**PLANNING COMMISSION MEETING
DECEMBER 01, 2021 AT 6:30 PM
505 EAST 2600 NORTH
NORTH OGDEN, UT 84414**

Staff Report to the North Ogden City Planning Commission

Application Request: Consideration and action regarding an administrative application, site plan approval of a building footprint expansion and parking lot expansion located at 2251 N. Washington Boulevard.

1 NORTH BUILDING ELEVATION
1/4" = 1'-0"

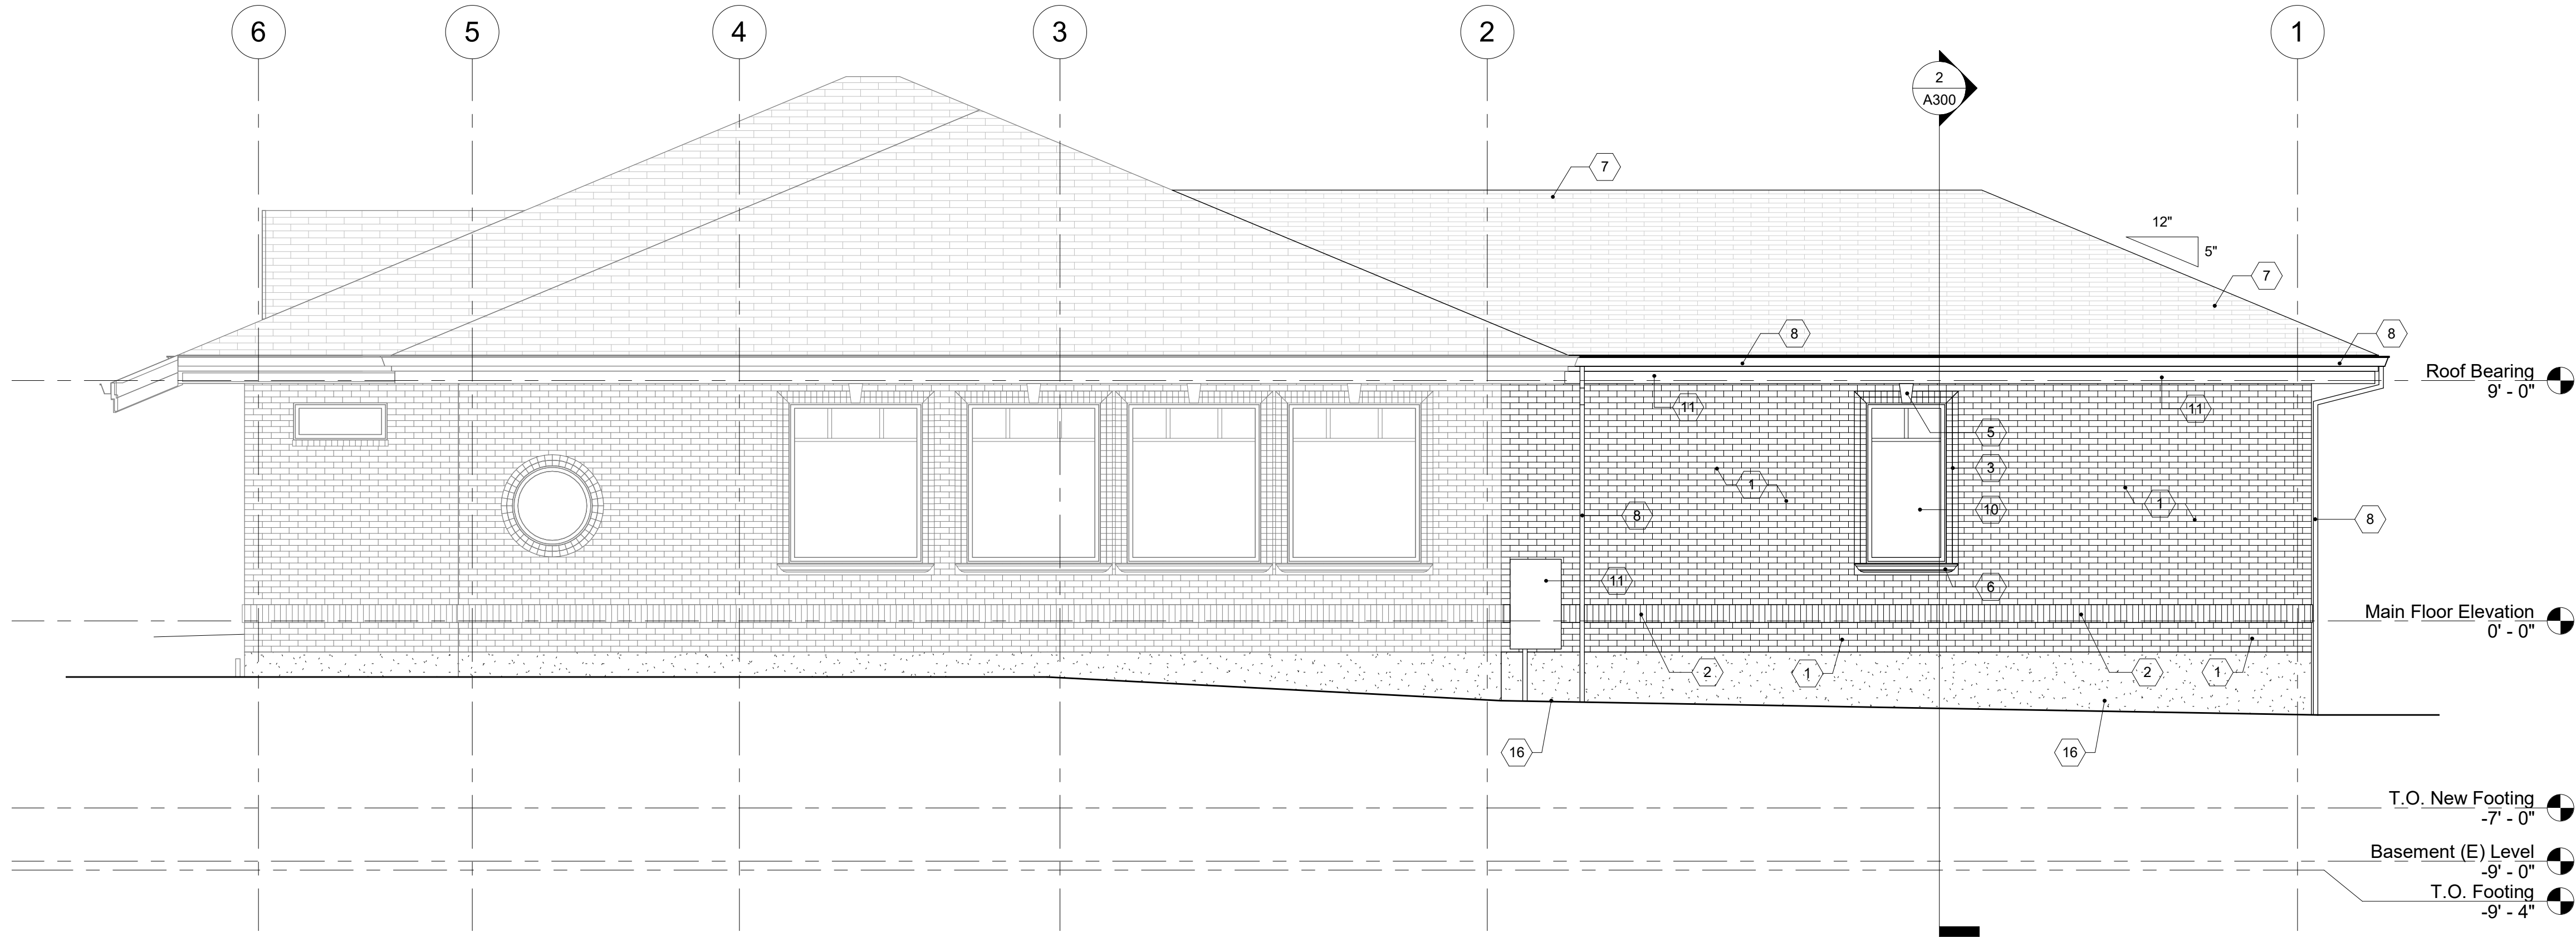
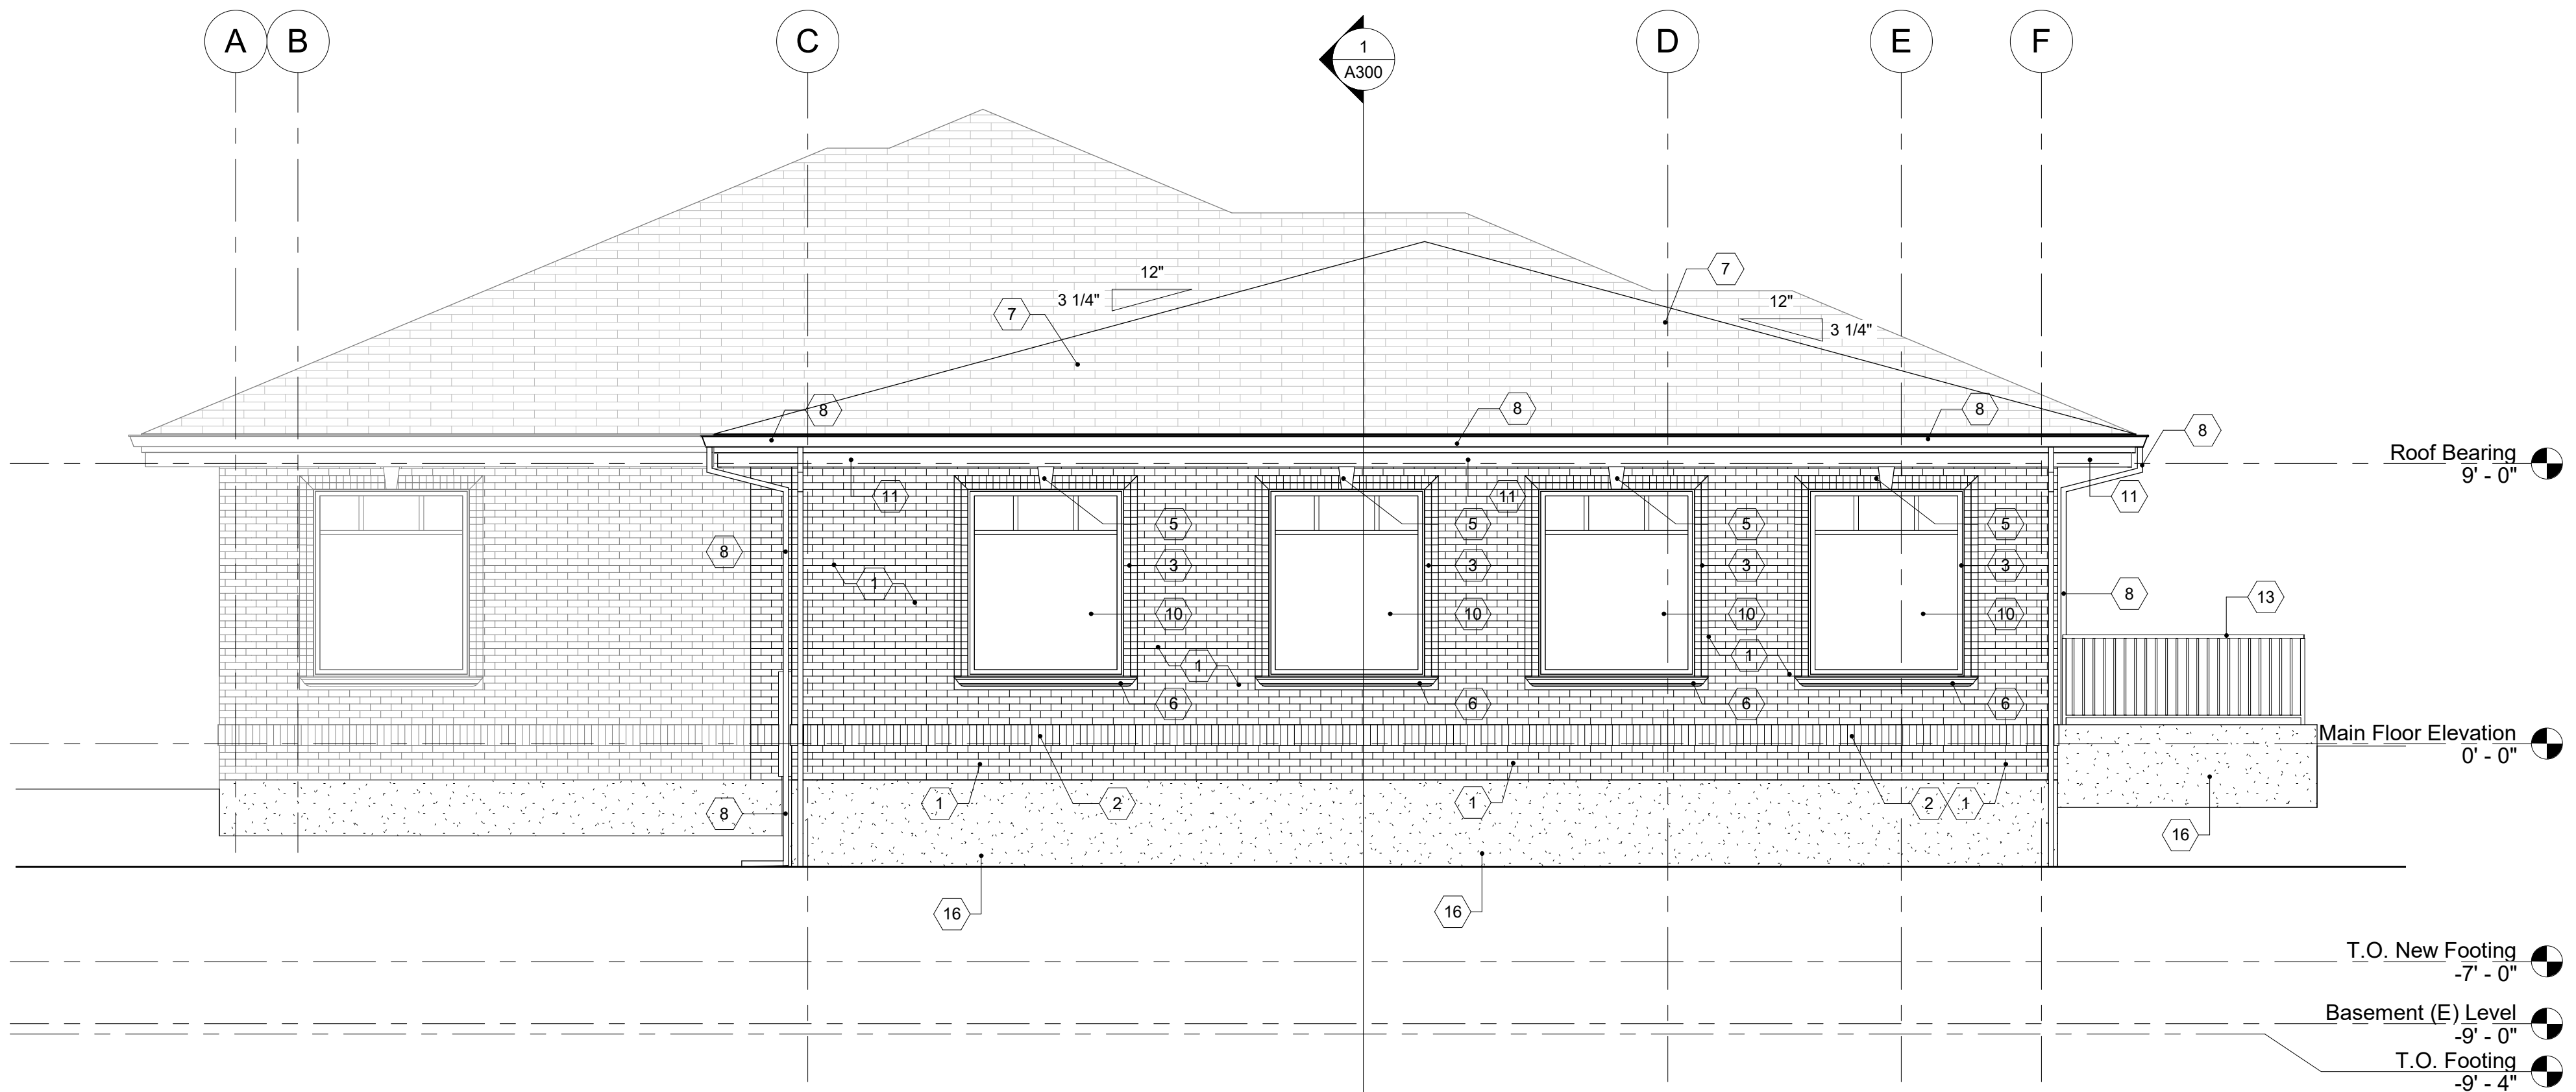
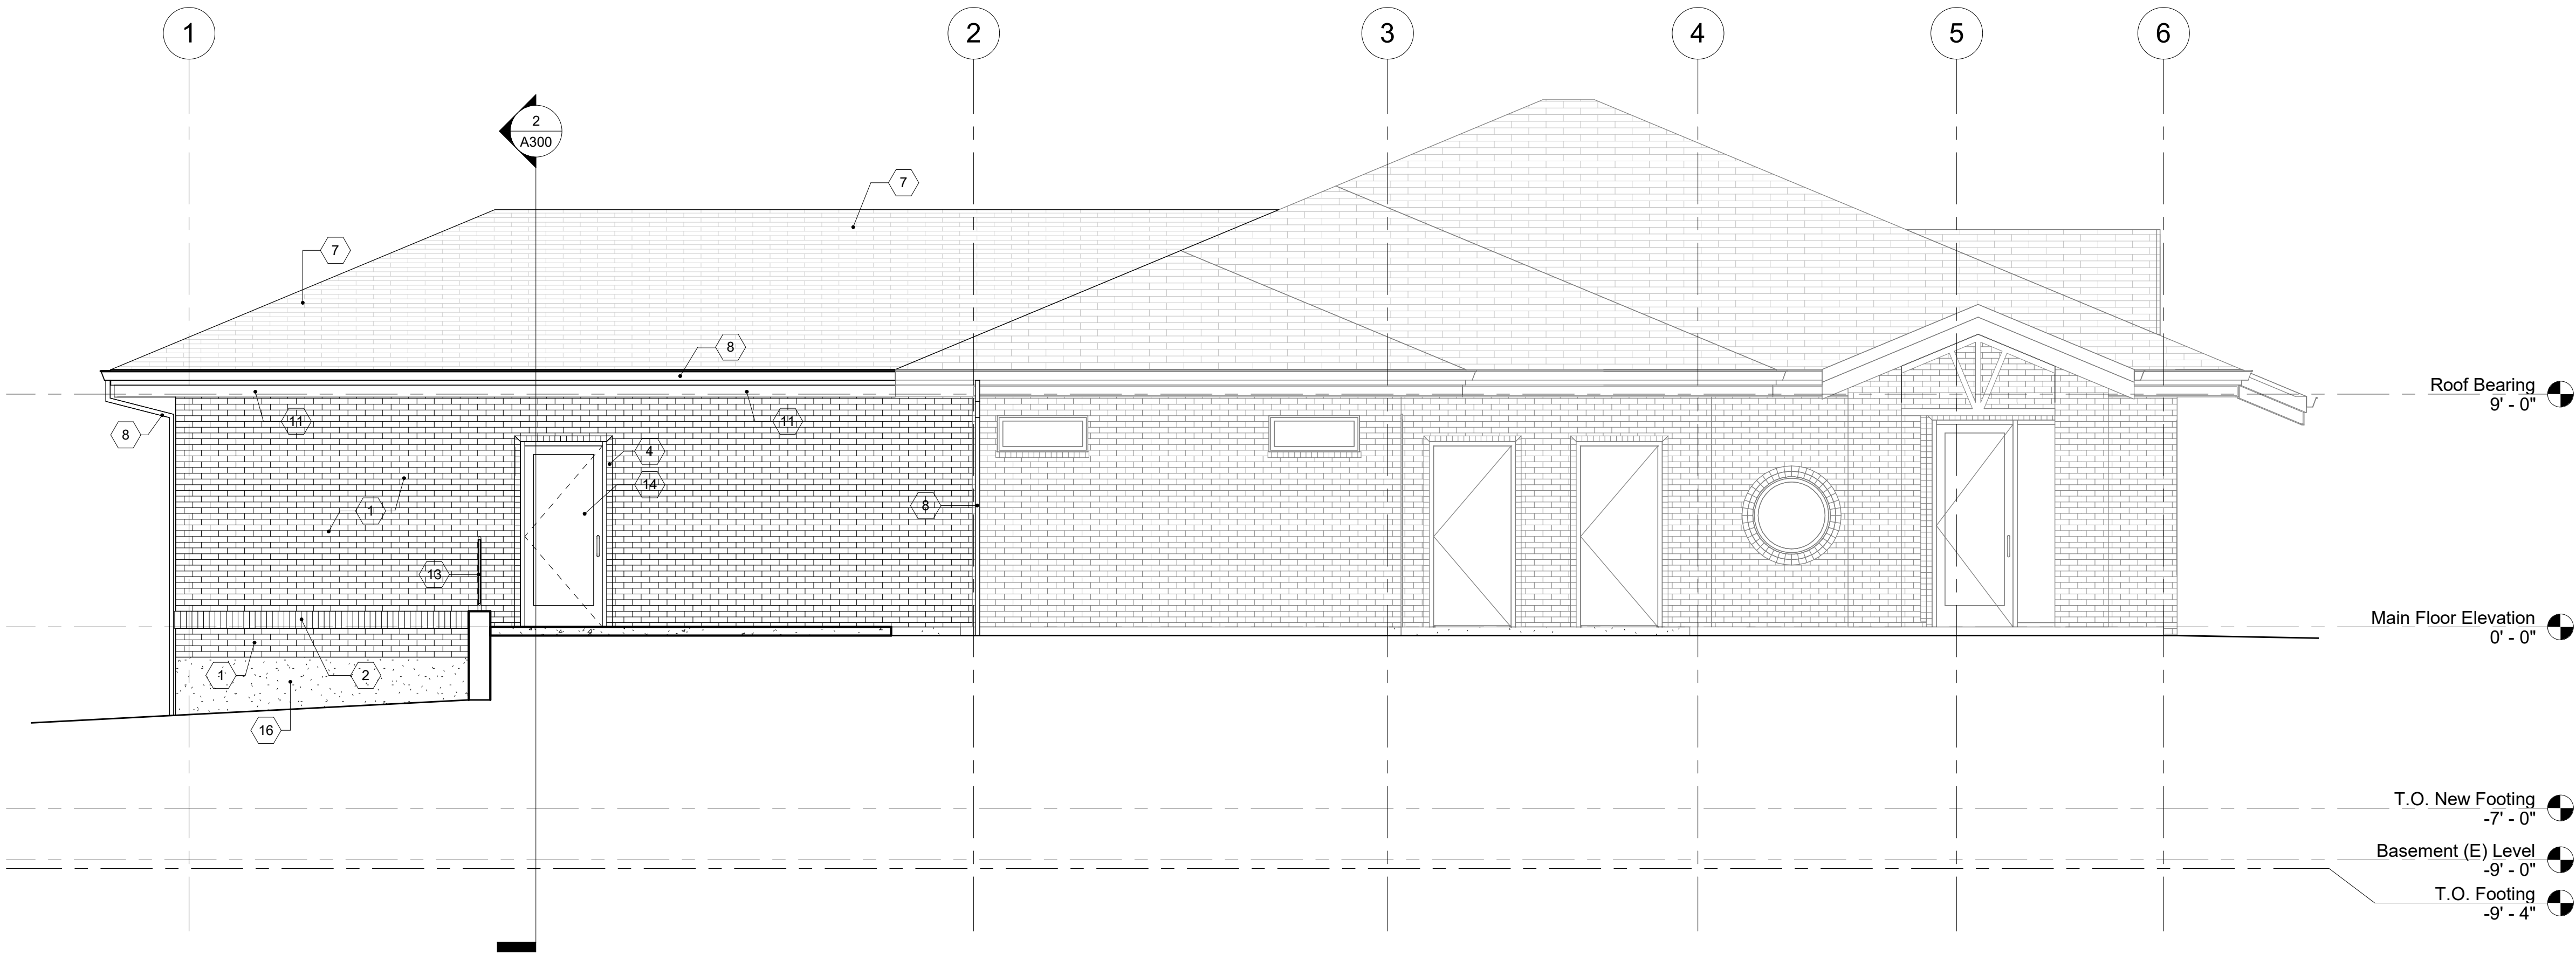
Staff Comment: The building expansion is proposed to match the existing all brick façade of the dental office. This is a muted earth tone, and appears to be generally in accordance with the requirements of the design standards. The façade of the building expansion facing Washington Blvd has only a single window, however they are providing 4 large daylight windows facing North within the examination rooms. The glazing has been found by staff to be in compliance with the design guidelines of the City Code.
